LAND USE APPLICATION COMPLETENESS REVIEW

Subject Property: 1105 Front Street NE

Reference Nos.: 24-106451-PLN (Class 3 Site Plan Review, Tentative Subdivision Plan, Class 1 & 2 Adjustment, Class 2 Driveway Approach Permit)

1 LANDSCAPE LAND USE DIAGRAM

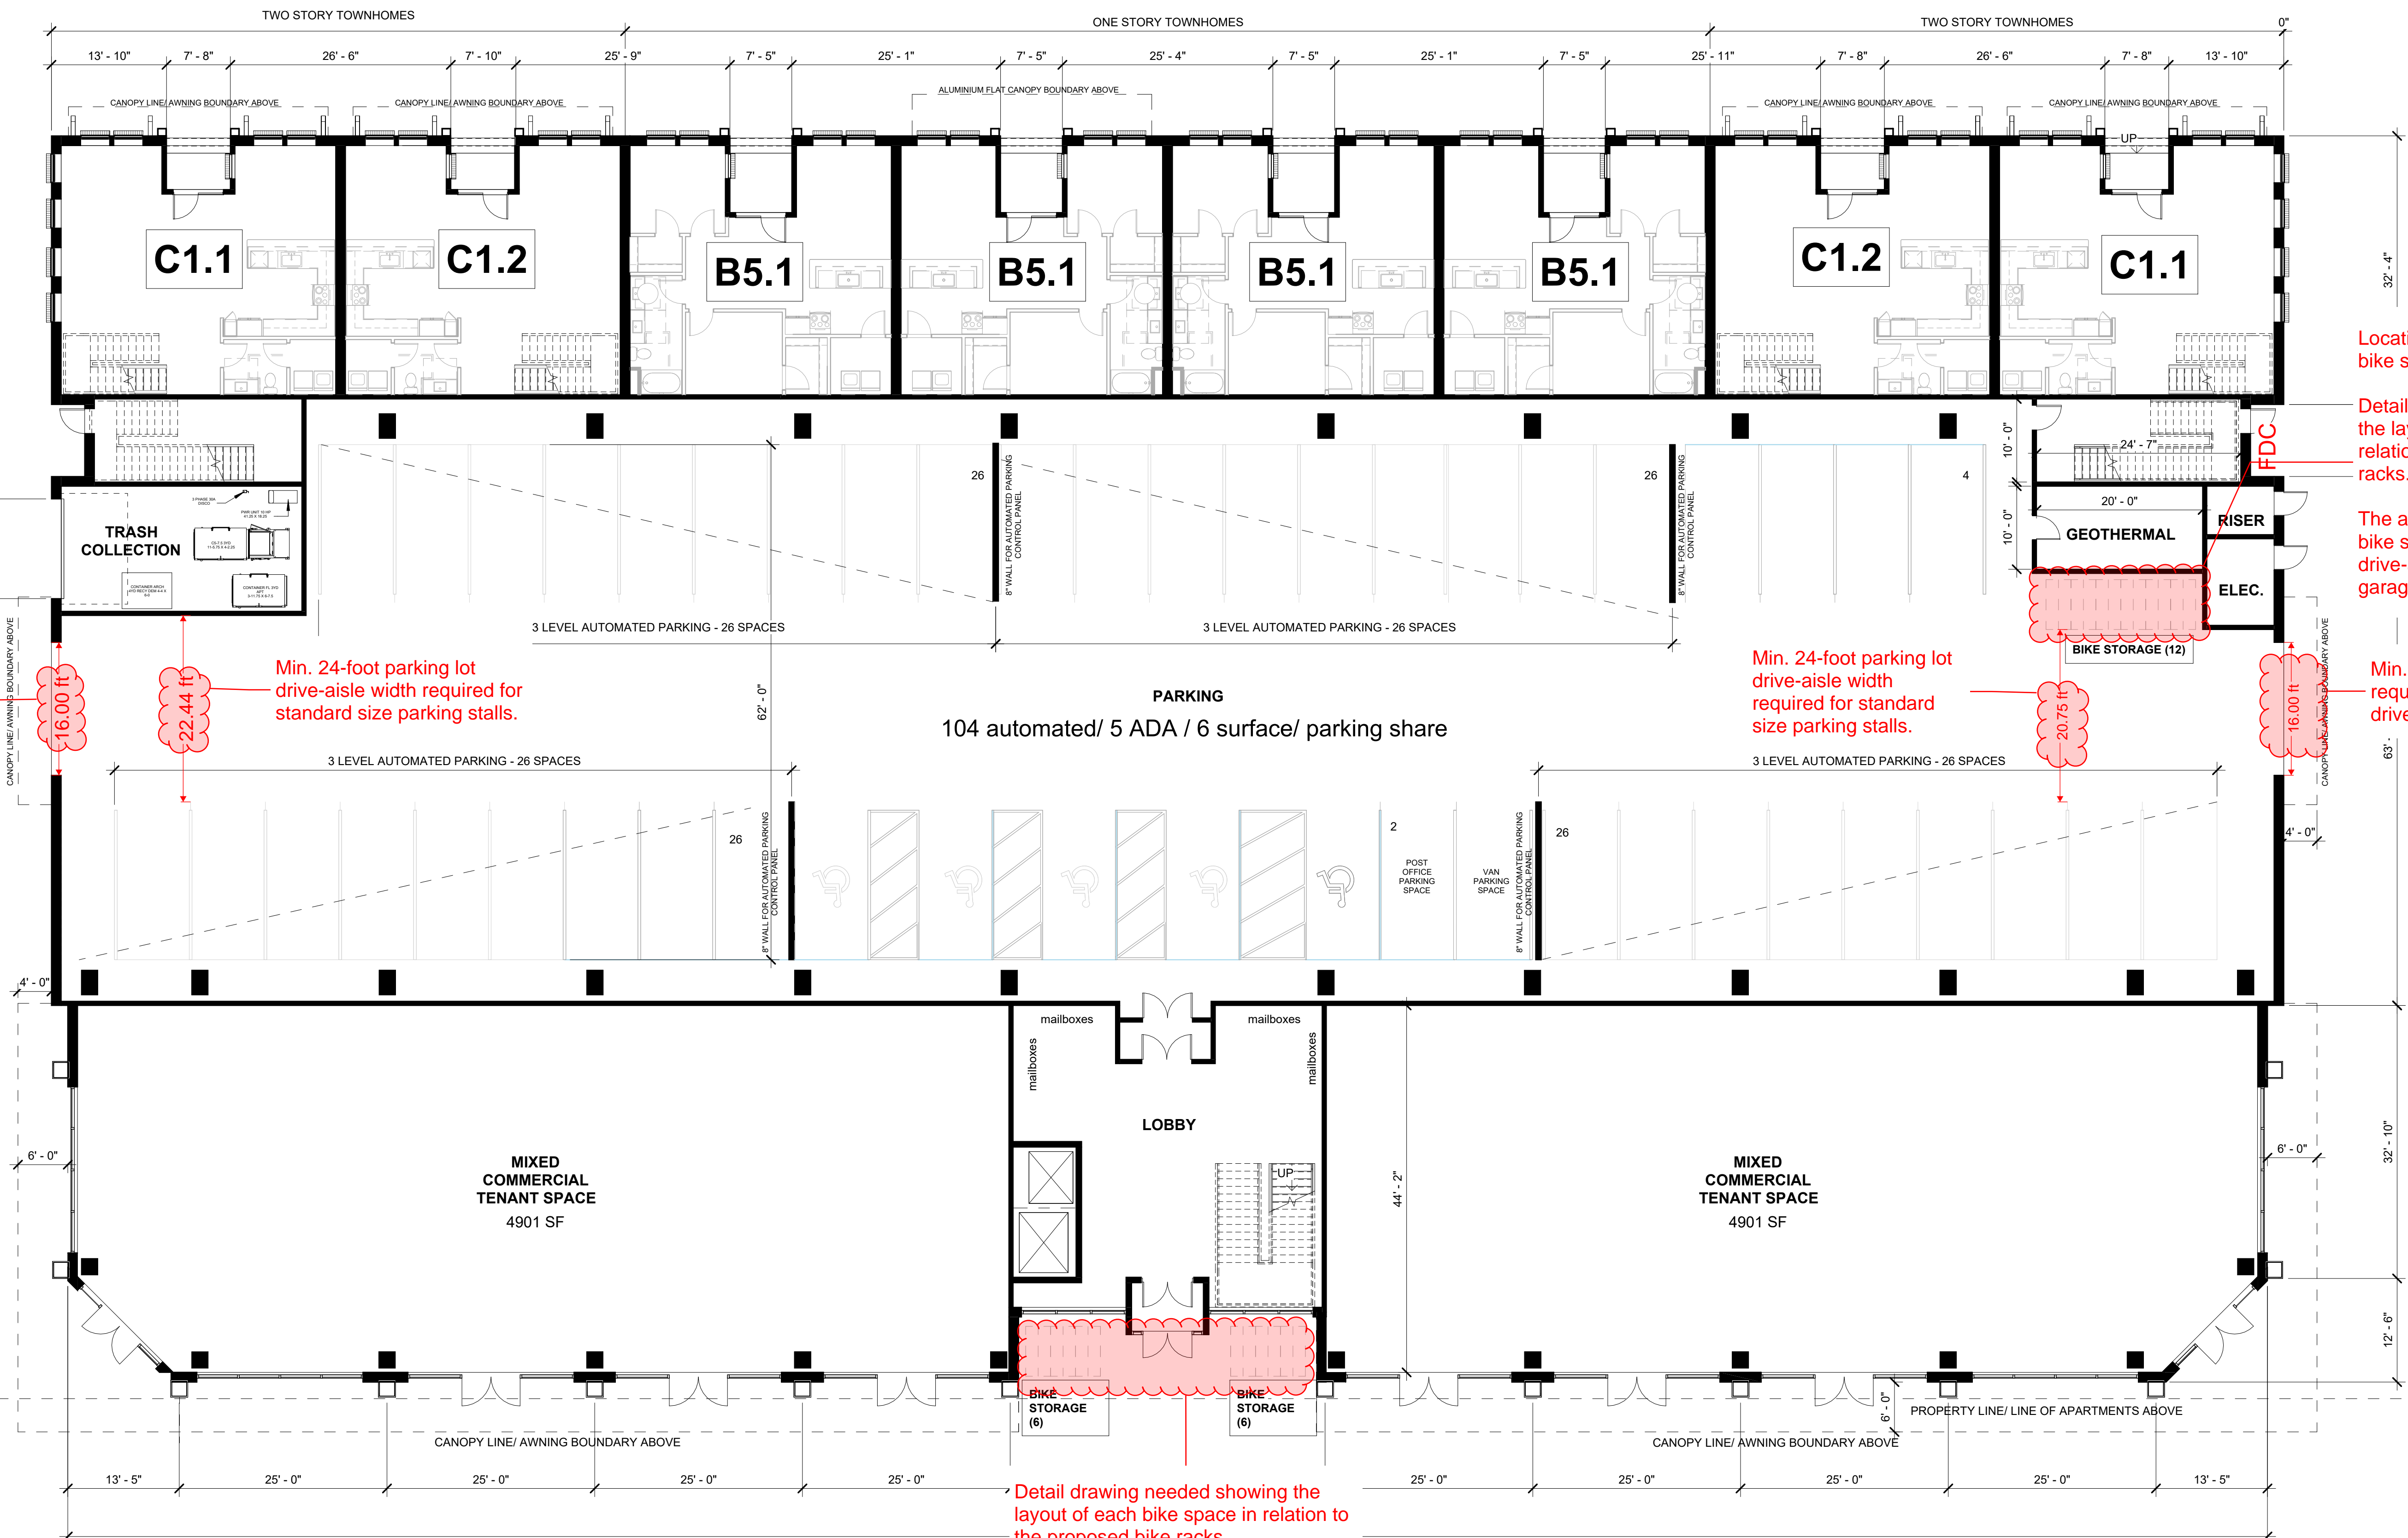
Additional Standards for New Surface Parking More than One-Half Acre in Size:
-The new surface parking lot area is more than one-half acre in size. Therefore, the additional new large parking lot landscaping standards adopted in response to the State's Climate Friendly & Equitable Communities (CFEC) administrative rules apply.

The additional landscaping standards are included under **SRC 806.035(n)**.

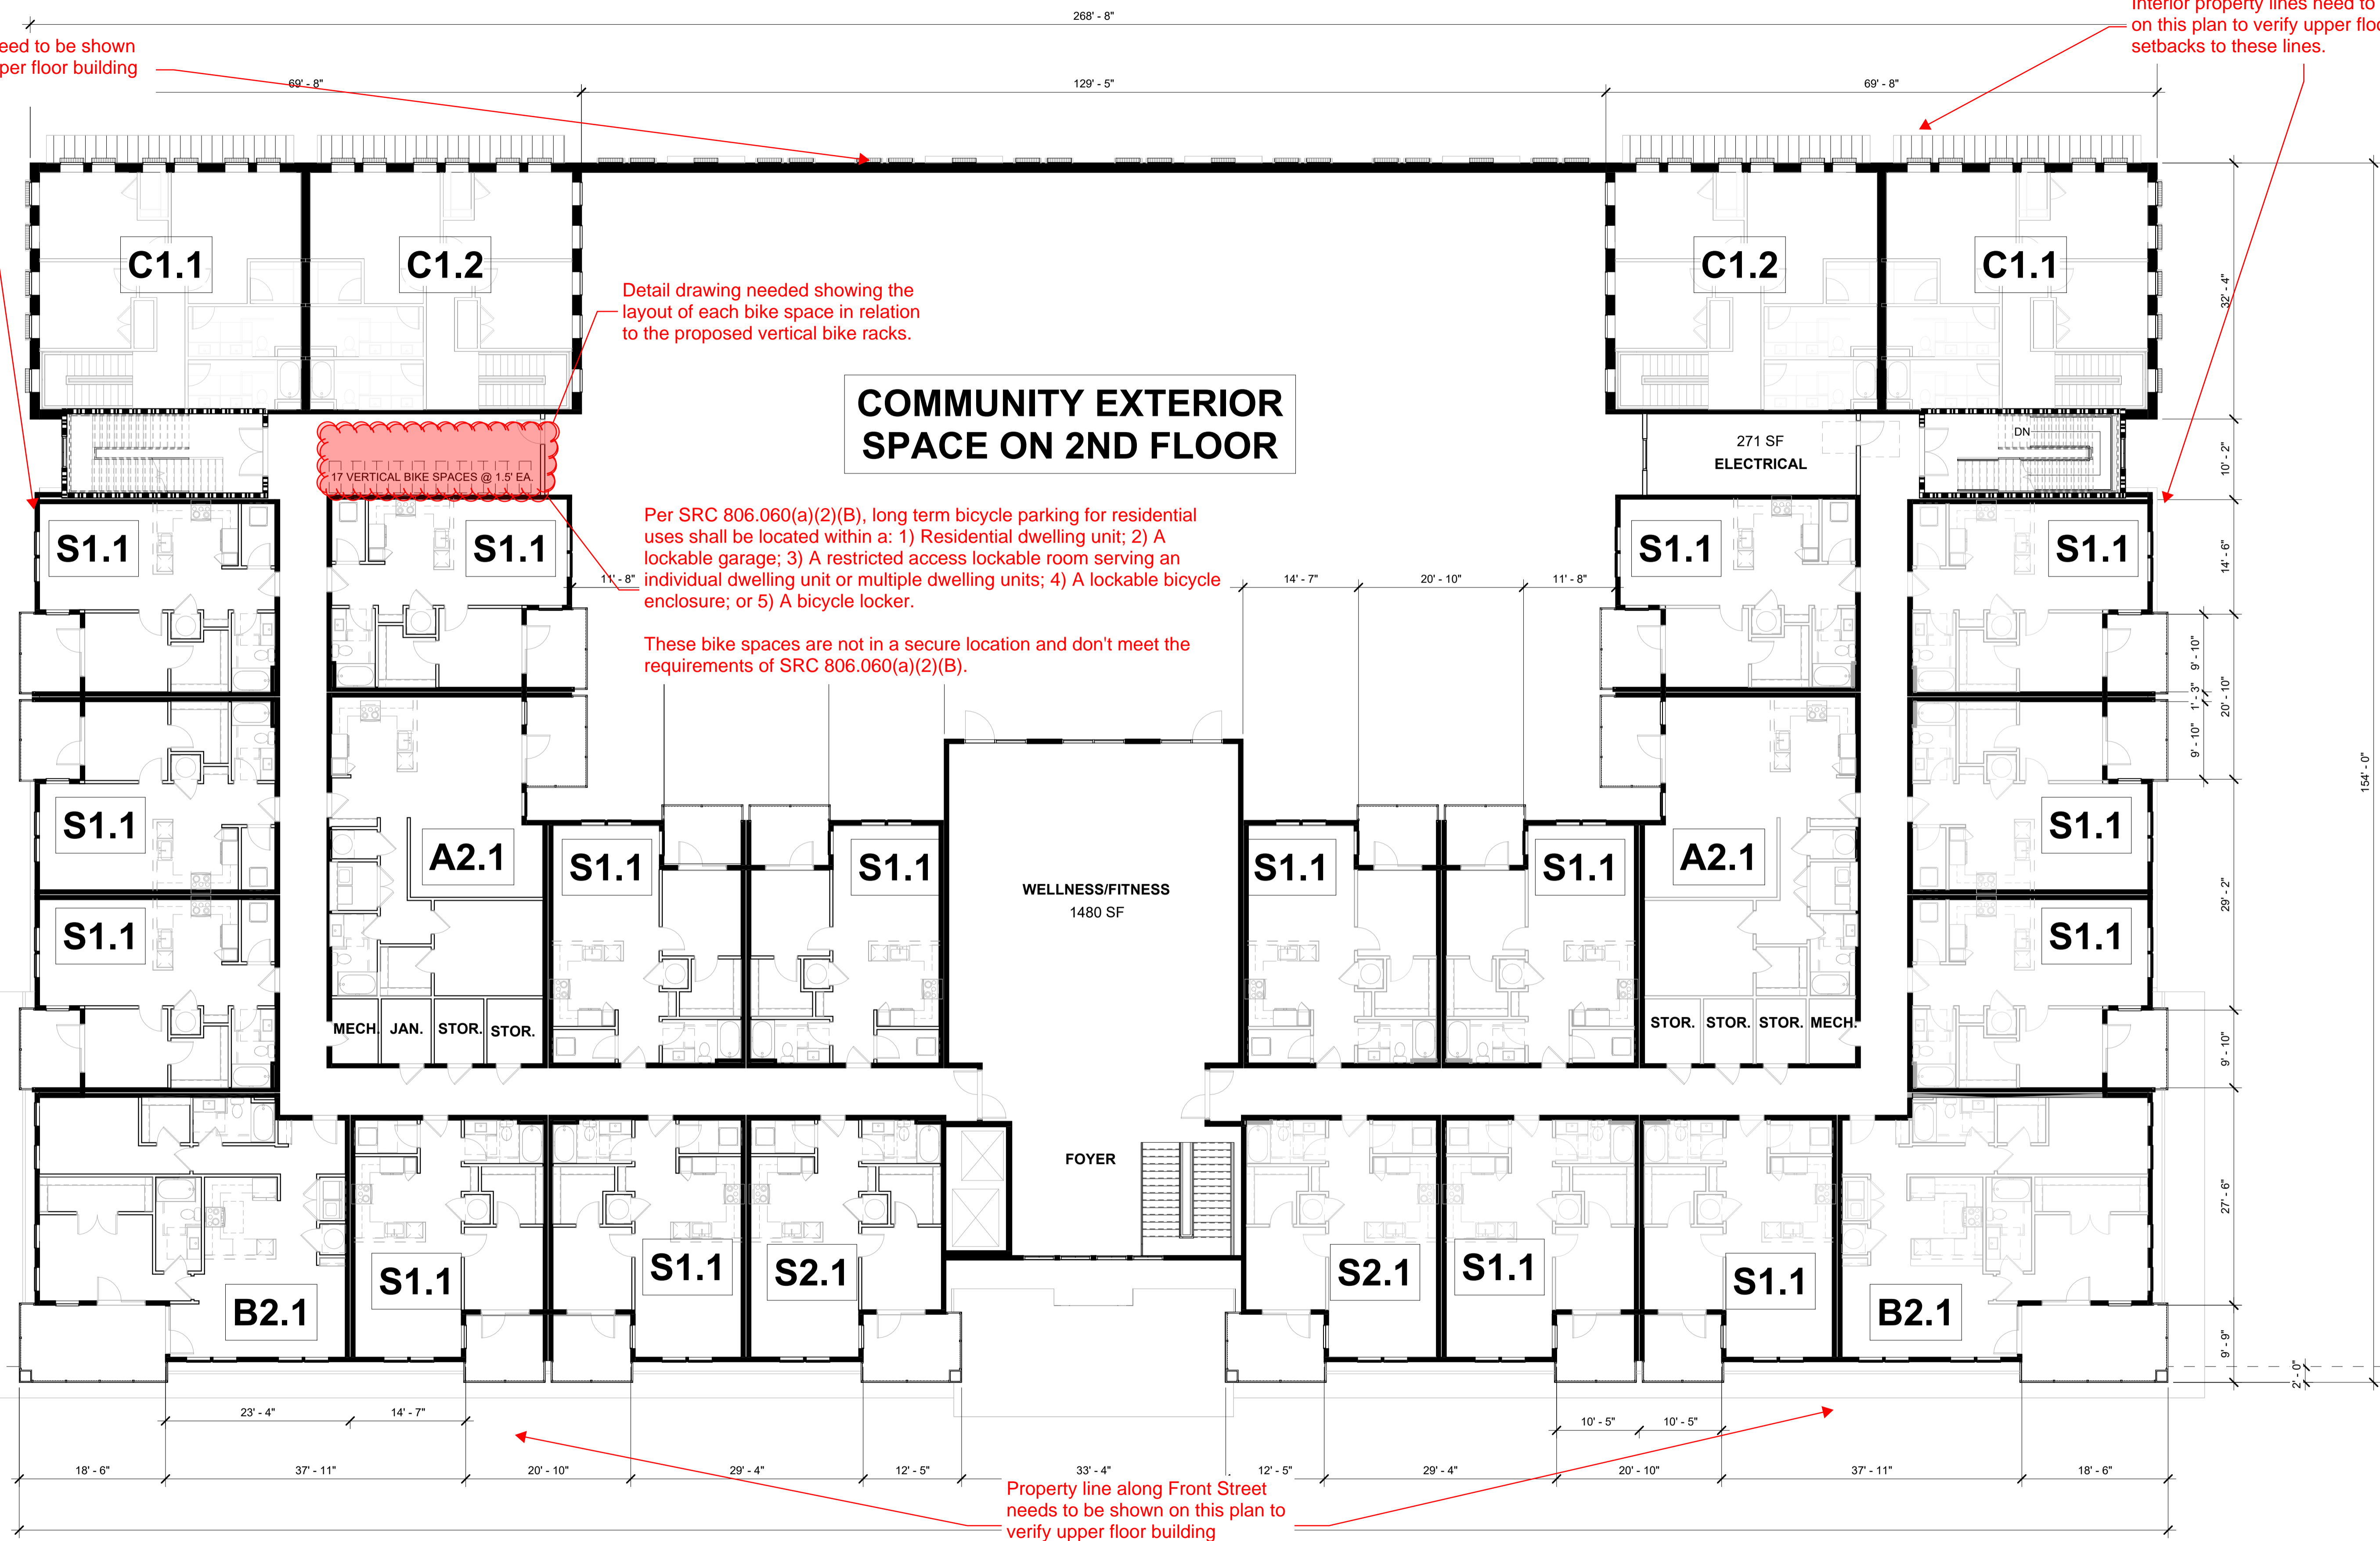
Ground Floor Building Height
 SRC 536.015(g) - Table 536-6 requires buildings with ground floors on primary streets to have a minimum ground floor height of 10 ft. For purposes of this stand ground floor height is measured from the floor to the ceiling of the first floor. The applicant's written statement indicates that the ground floor height of the building is 18 feet. However, in review of the building elevations it looks like the 18-foot height is measured from the floor of the first floor to the floor of the second floor. Confirmation is needed regarding the ground floor height of Buildings 1, 2, and 3 measured from floor to ceiling of the first floor.

Min. 22-foot opening required for two-way driveway.

Min. 24-foot parking lot drive-aisle width required for standard size parking stalls.

Location of bike racks don't meet bike standards of SRC 806.060.

Detail drawing needed showing the layout of each bike space in relation to the proposed bike racks.

The access aisle to get to the bike spaces is located in the drive-aisle into the parking garage.

Detail drawing needed showing the layout of each bike space in relation to the proposed bike racks.

Interior property lines need to be shown on this plan to verify upper floor building setbacks to these lines.
